**ZONING CHANGE REVIEW SHEET****CASE:** C814-2017-0001 – 425 W. Riverside PUD**Planning Commission Date:** February 13, 2018  
February 27, 2018**ADDRESS:** 425 W. Riverside Drive**OWNER/APPLICANT:** Ronald A. Nelson and Molly Belle Properties (Ronald Nelson, Trustee)**AGENT:** Armbrust & Brown (Richard Suttle)/Stream Realty (David Blackbird)**ZONING FROM:** CS-1-V-NP      **TO:** PUD-NP**AREA:** 1.45 acres (63,162 sq. ft.)**SUMMARY STAFF RECOMMENDATION:**

- This report includes all comments received to date concerning your proposed planned unit development. The PUD will be scheduled for Commission when all requirements identified in this report have been addressed.
- PLEASE NOTE: IF YOU HAVE ANY QUESTIONS, PROBLEMS, CONCERNS OR IF YOU REQUIRE ADDITIONAL INFORMATION ABOUT THIS REPORT, PLEASE DO NOT HESITATE TO CONTACT YOUR CASE MANAGER (referenced above) at the CITY OF AUSTIN, PLANNING AND ZONING DEPARTMENT, P.O. BOX 1088, AUSTIN, TX.

EXHIBIT D - LAND USE PLAN - NOTES

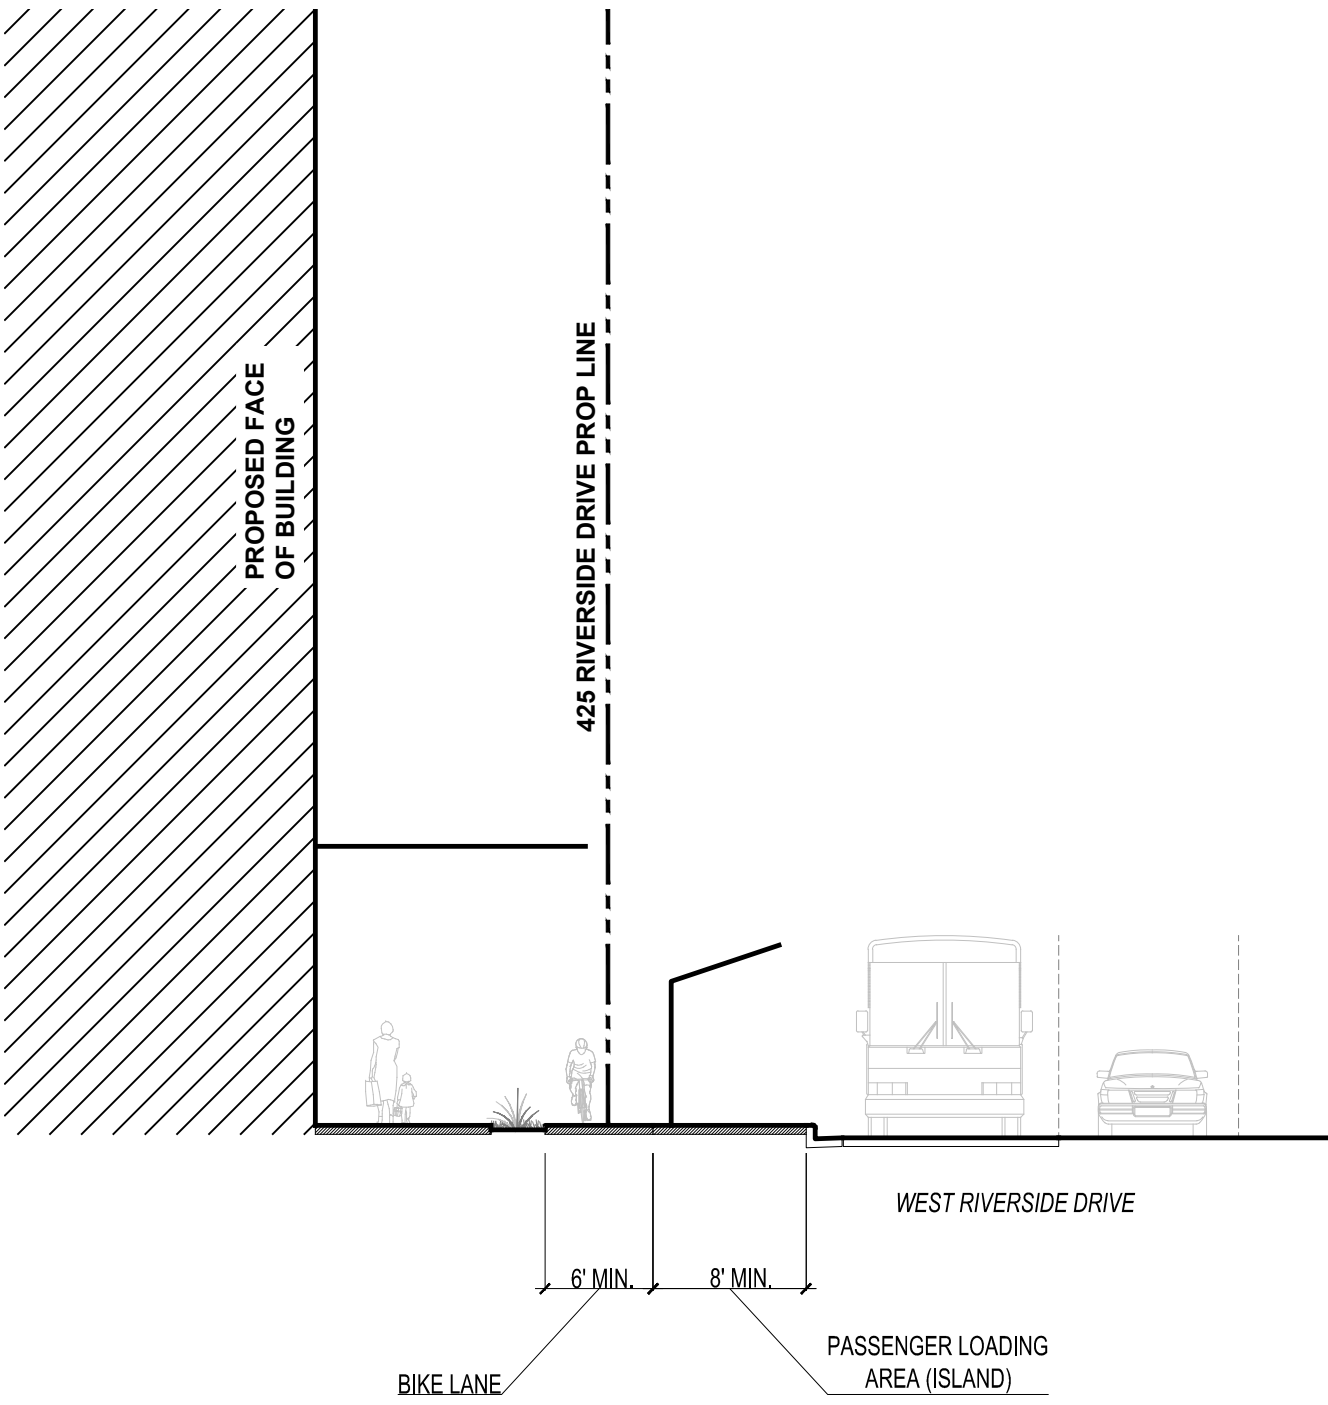
- #1 Corner radiuses: I’m OK with the 25’ radius representation on the land use plan – Exhibit C under the assumption that these show effective radiuses and that details of ADA ramp and bikeway configurations and actual curb radiuses will be decided at site plan (while conforming to the effective radius.

- #2 On exhibit C, note 4 should be removed. In the above comment we need to retain the ability to design the corners and bikeway interactions at site plan. A single curb ramp is not preferred from an pedestrian / bicycle design and may not align with ADA requirement / best practices.

**The PUD ordinance requires code modifications to be listed on the Land Use Plan. Please add these to Exhibit D. Update can be Informal.**

EXHIBIT E - STREET CROSS-SECTIONS

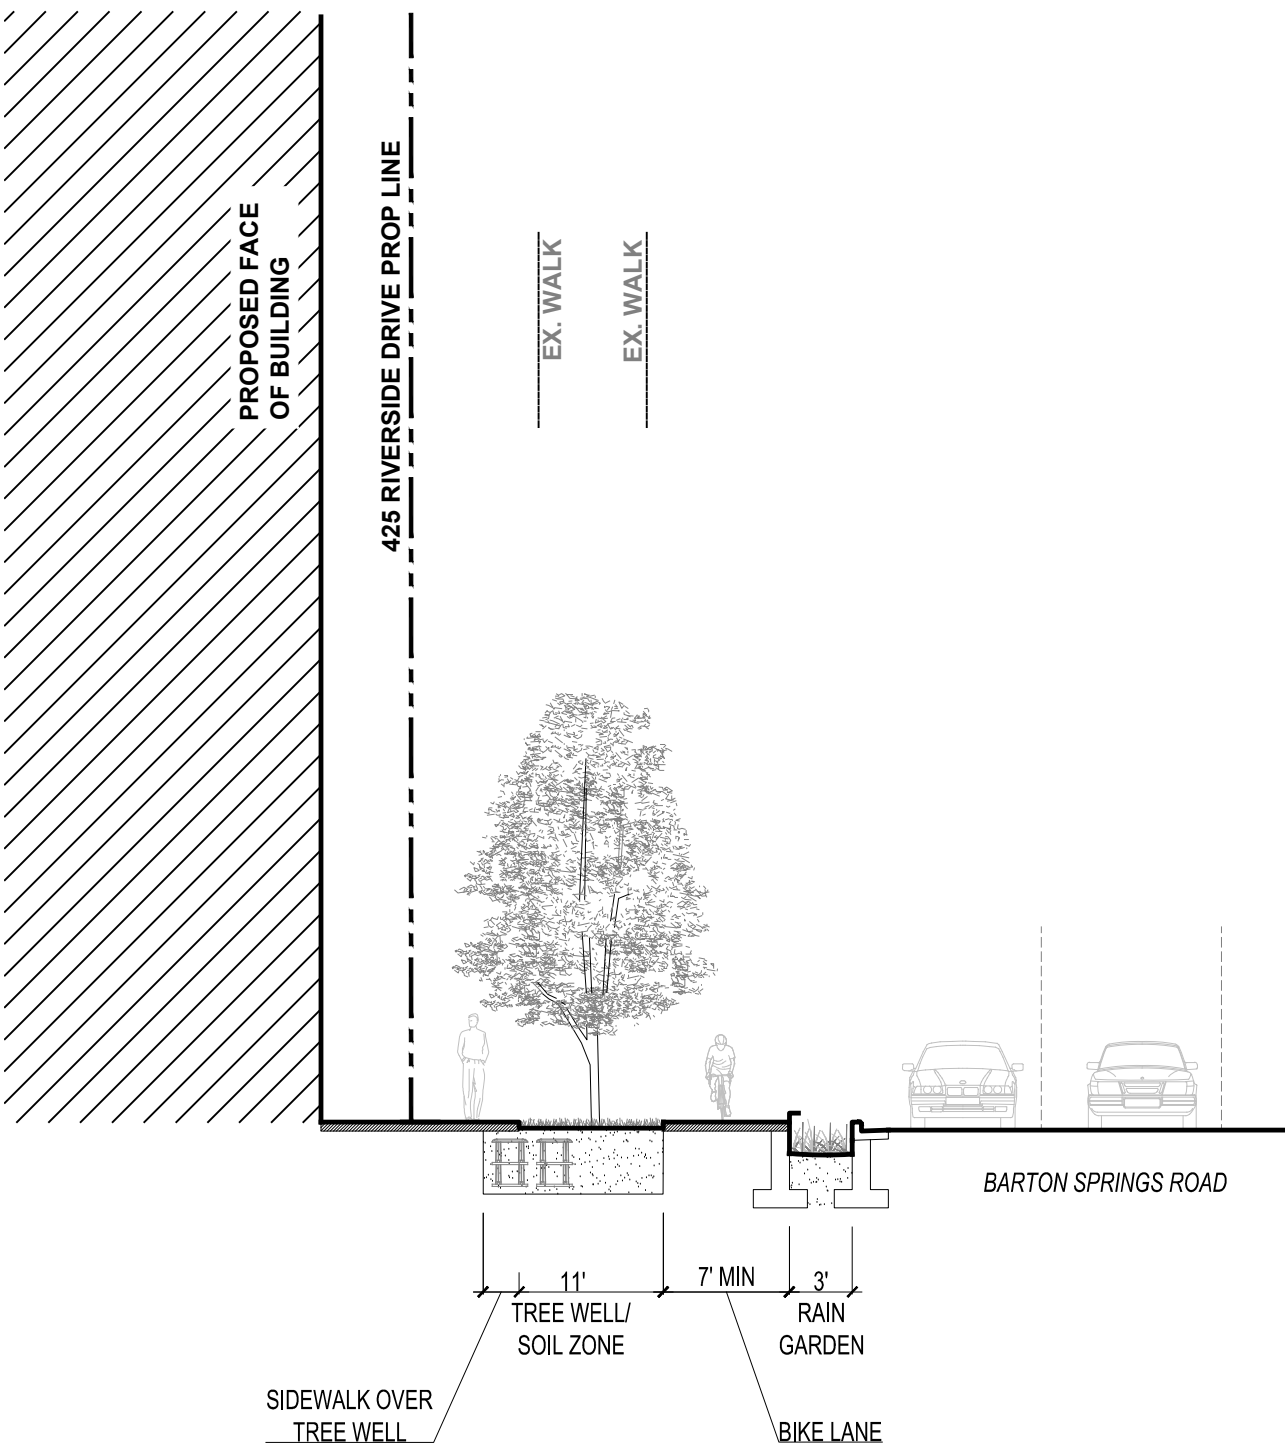
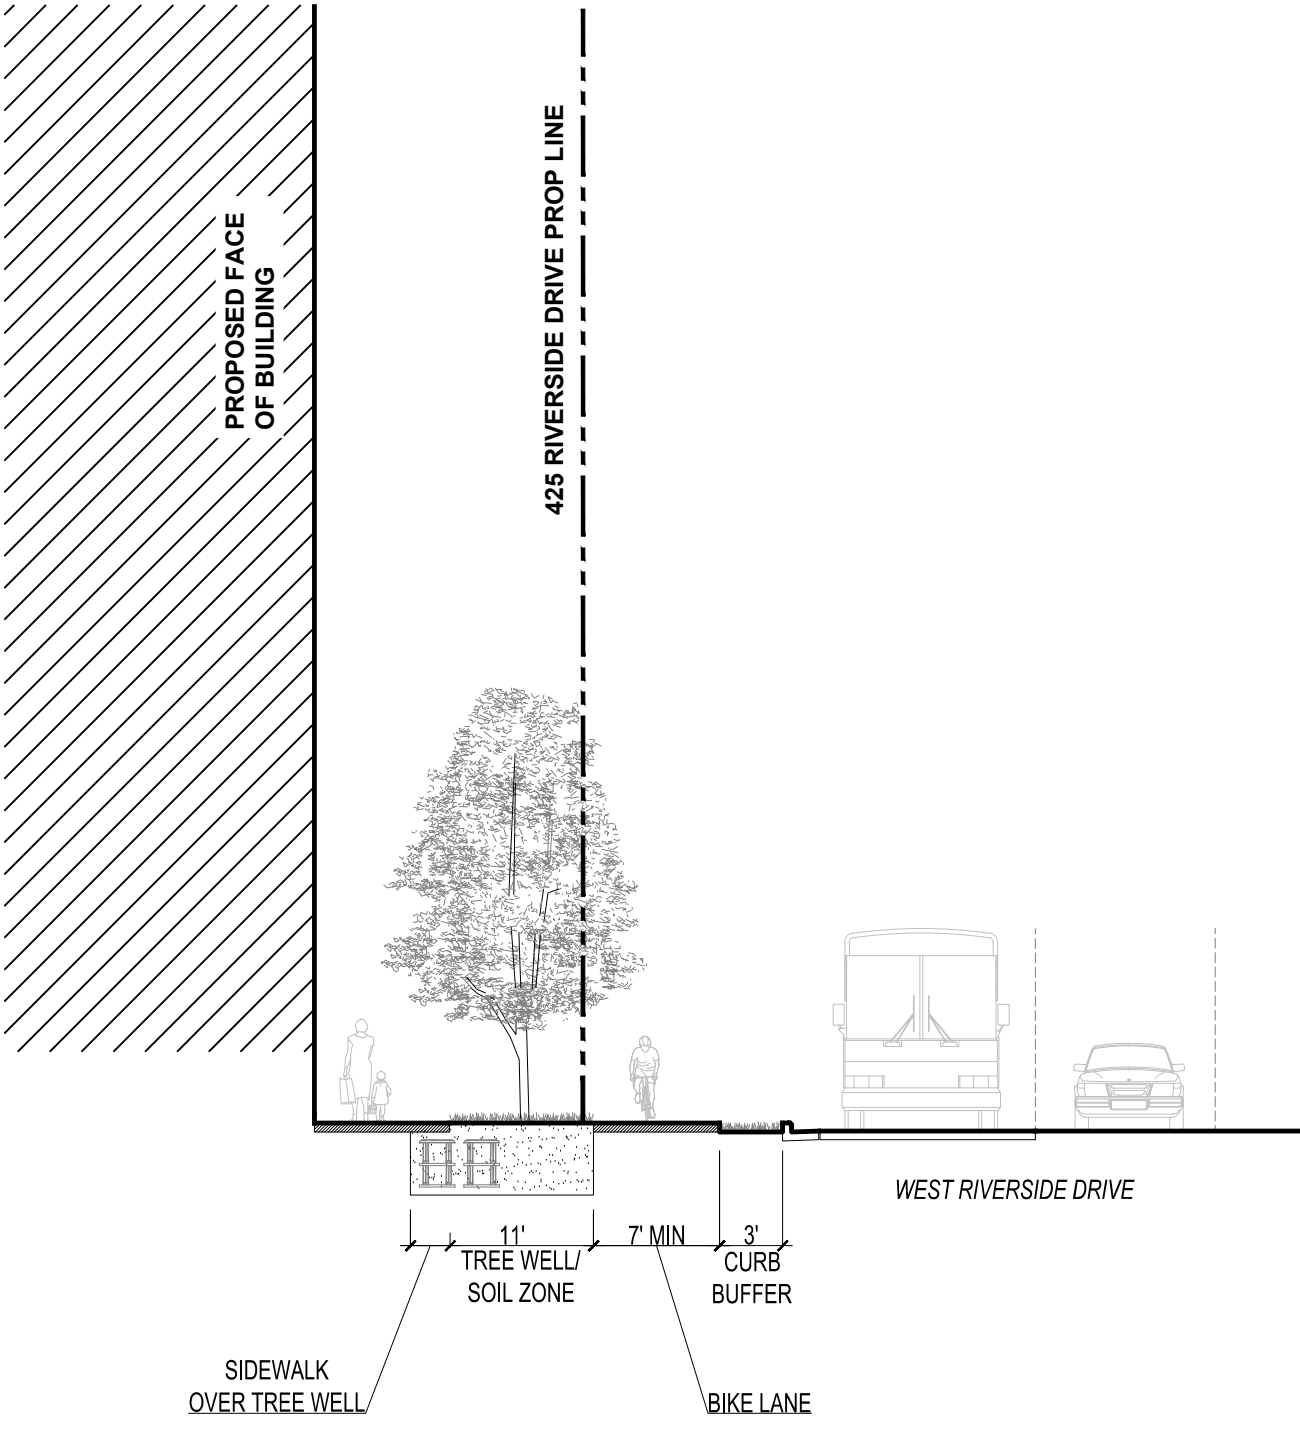
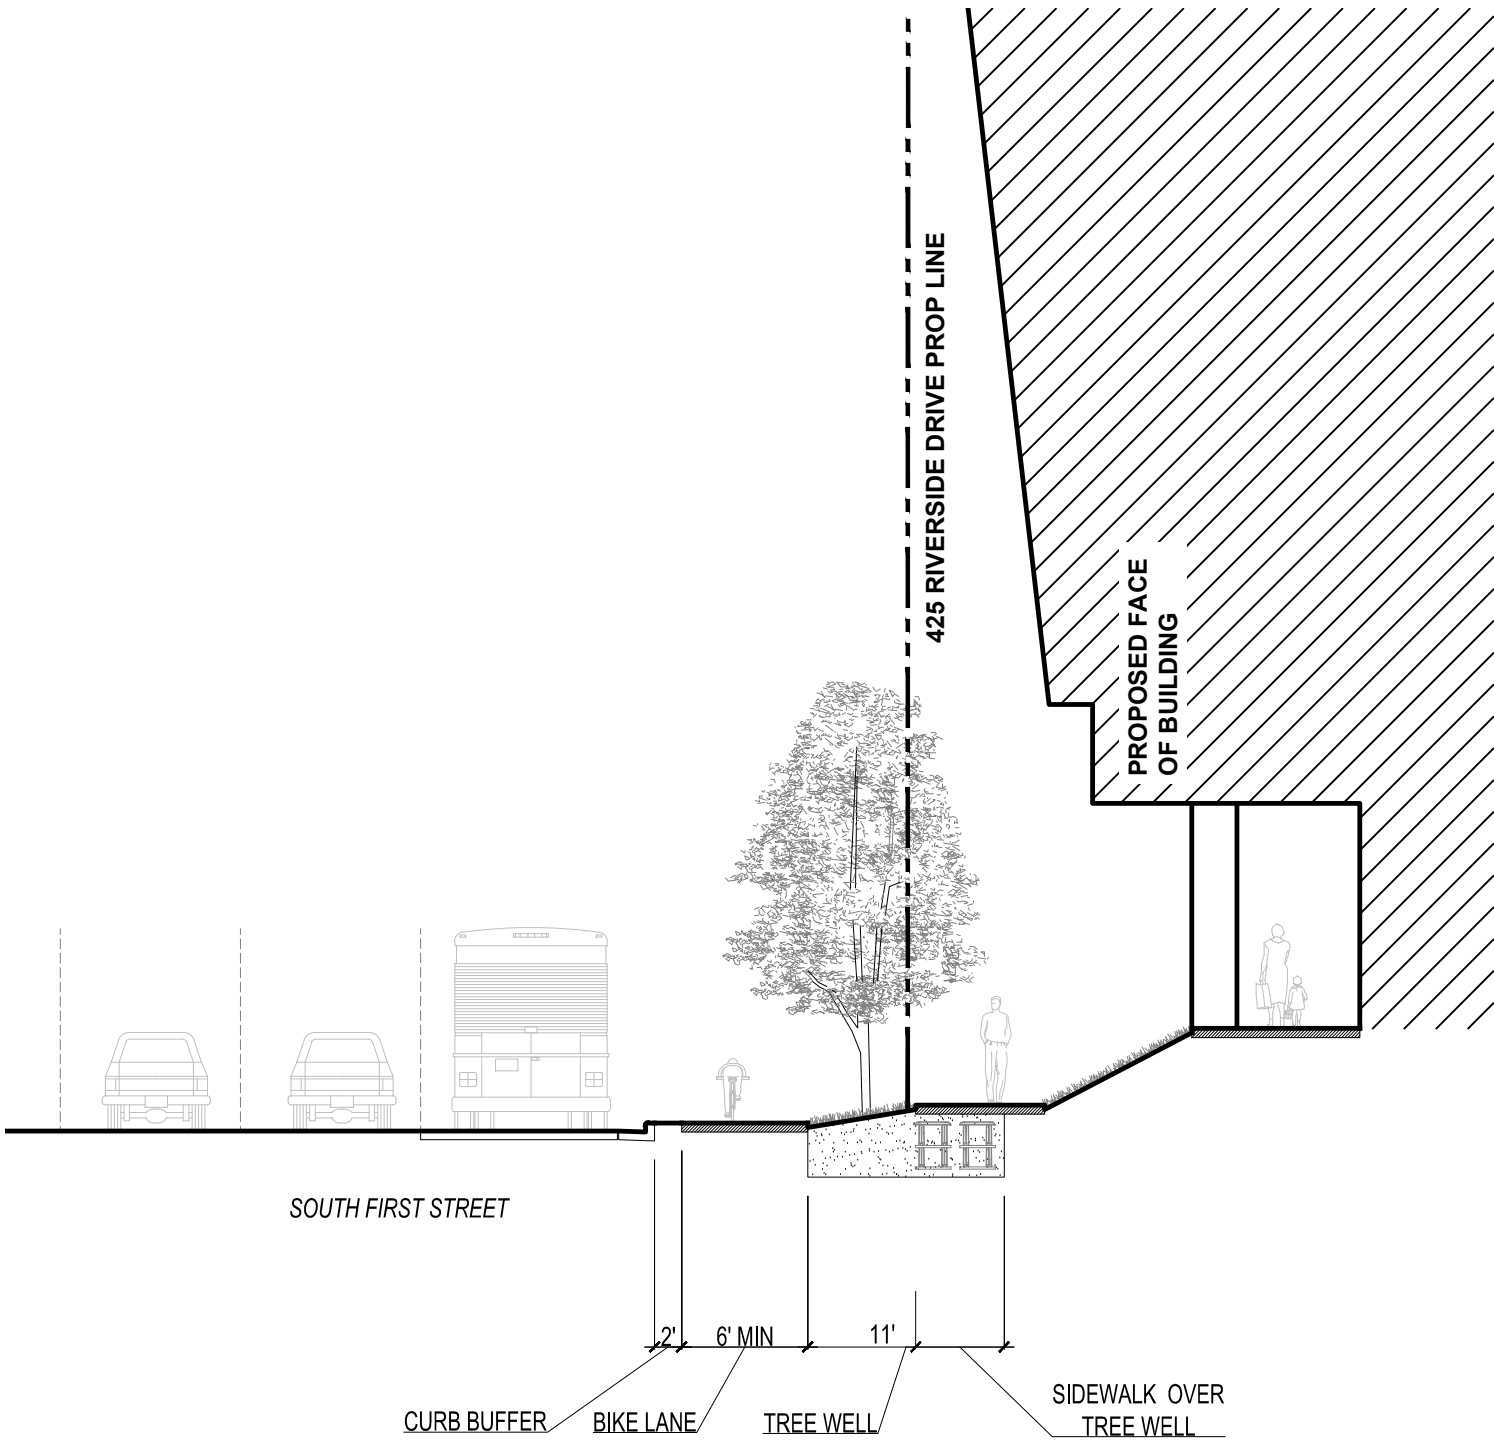
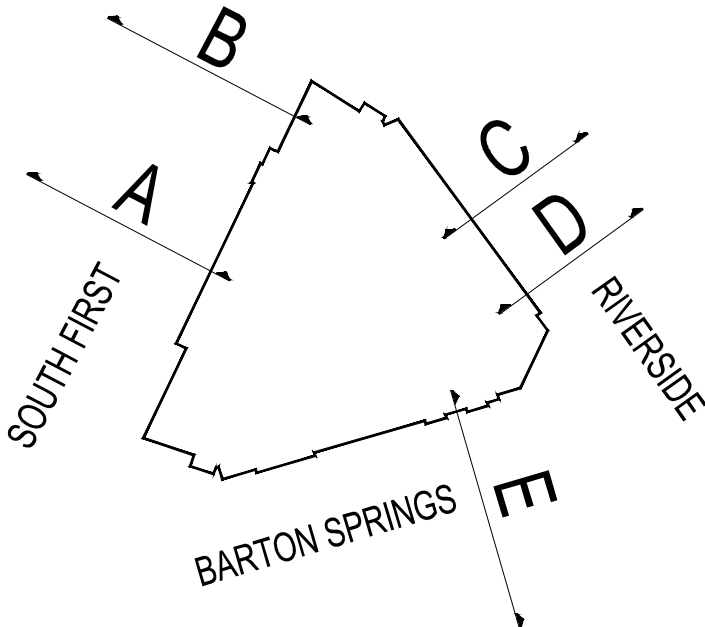
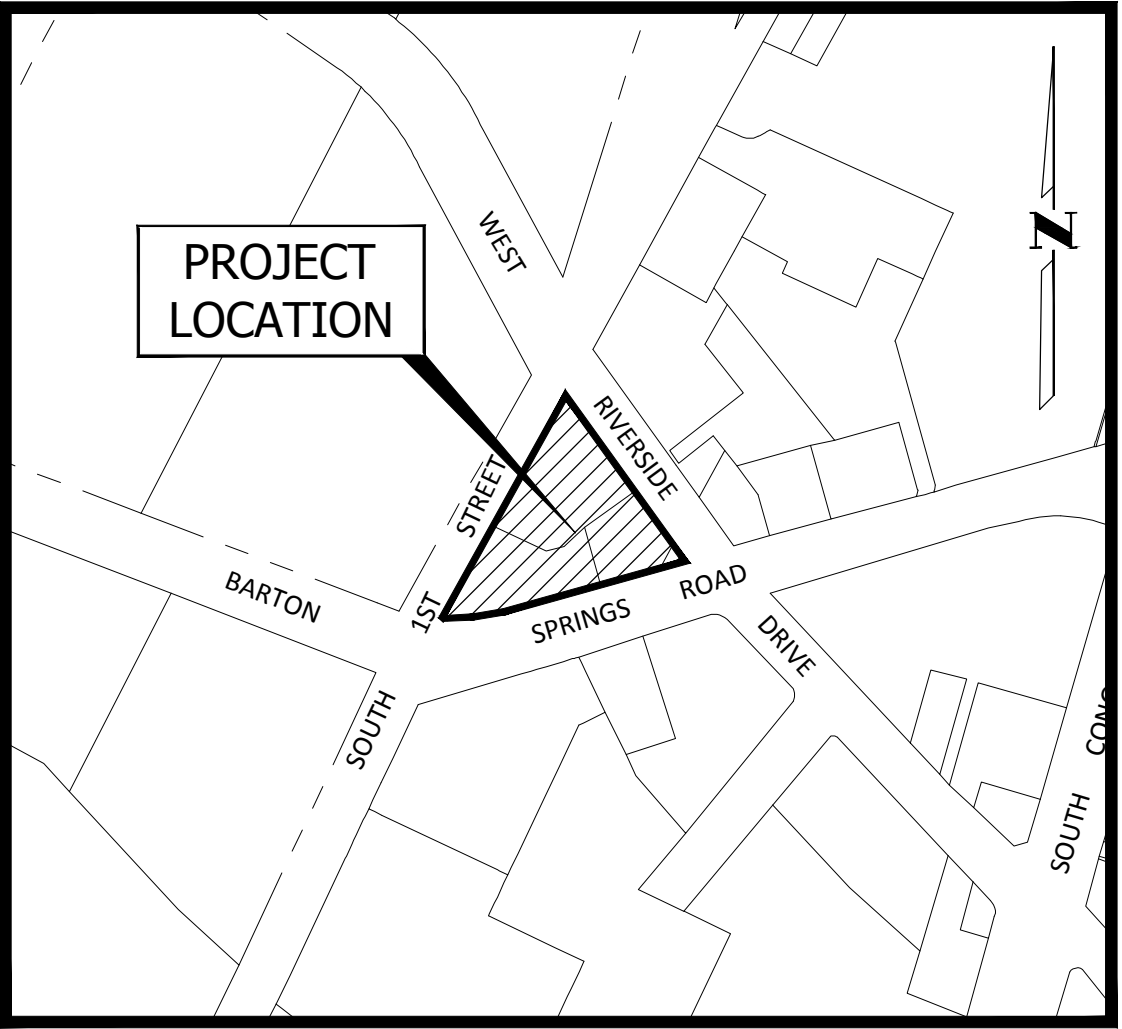
- #3 Bicycle Lane Width - the bicycle lane widths do not conform to the original drawing I sent in May. In the attached Exhibit C and E I have marked up width changes. In short the following are the dimensional requirements for the bicycle lane in a few scenarios:  
If pavement on either side of bicycle lane is not rideable than 7' is the minimum bikeway dimension.

If there is a dropoff into a rain garden there needs to be a hand rail that is recessed from the bike lane by 6" as to not encroach in the bicycle lane space (handrails should be added to relevant cross sections in exhibit E. If there is rideable pavement on both sides of the bike lane the minimum acceptable dimension is 6'
